Victorian Society Testimony for May 13, 2025: 956 Park Place (LPC-25-08411); 430 Lafayette Street - NoHo Historic District and Individual Landmark (LPC-24-11008); 284 Fifth Avenue – The Wilbraham - Individual Landmark (LPC-25-09203); 228 Lenox Avenue (LPC-25-08473); 35 Remsen Street (LPC-25-02663); 310 Malcolm X Boulevard (LPC-25-02849)

LPC-24-11008 -- 430 Lafayette Street - 430 Lafayette Street Building - NoHo Historic District - Individual Landmark, Manhattan

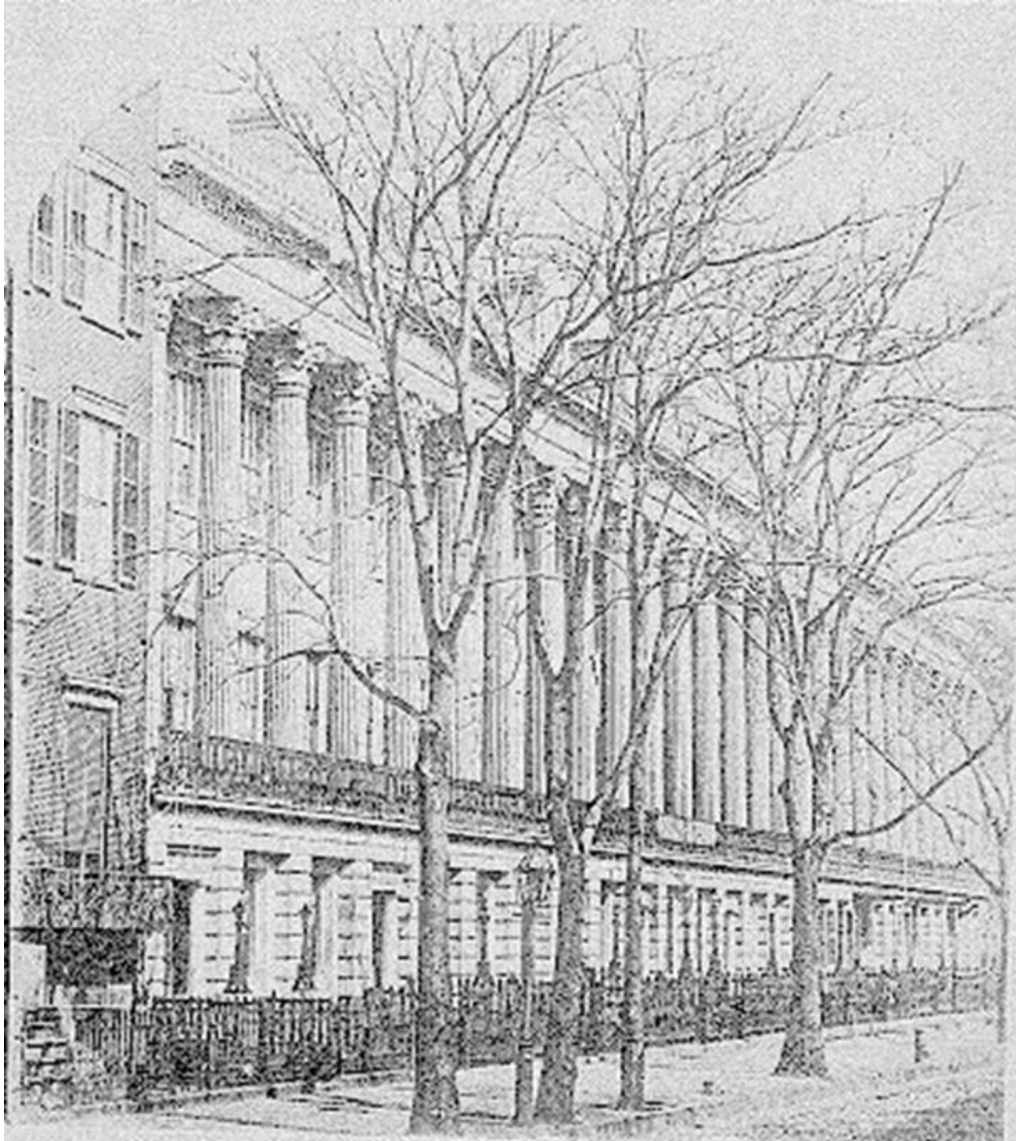
Good morning commissioners, _____ for the Victorian Society New York. With this application, we have seen within the past few months proposals for access at three of the four houses of Colonnade Row. We acknowledge that access should be provided at these buildings because of the commercial activities at the basements and ground floors. We also understand the difficulties of providing access if in fact the houses are under separate ownership and are not interconnected. But is this really the best we can do for these remarkable individual landmarks?

At typical rowhouses, lifts usually affect basement level entrances and areaways. At Colonnade Row, however, the main entrances have always been at the ground floor. Despite some alterations, the ground floor appearance of the houses seen in the earliest drawings and photographs of the row is largely intact. Lost details are restorable. Historic images of the row suggest potential solutions. See our written testimony.

Instead, the street level facades will be presented to the public as a series of hulking mechanical devices.

Our testimony on the previous two proposals for access noted the extremely deteriorated conditions of the buildings and asked why discretionary permits are being issued before restorative work is undertaken. We were told that the owners are working on testing masonry restoration materials. The permits for façade restoration were issued in 2018, seven years ago. They have expired. Masonry testing doesn't require seven years. Meanwhile, permits continue to be issued for interior alterations and for non-restorative exterior work that in some cases degrades the fabric and appearance of these buildings. This gives the owners no incentive to get moving with the restoration.

It's time for a more preservation-oriented approach from both the owners and this Commission towards these important landmarks. We again ask that this and other non-restorative permits not be issued until real progress is made on restoration.

Approved 10-0.
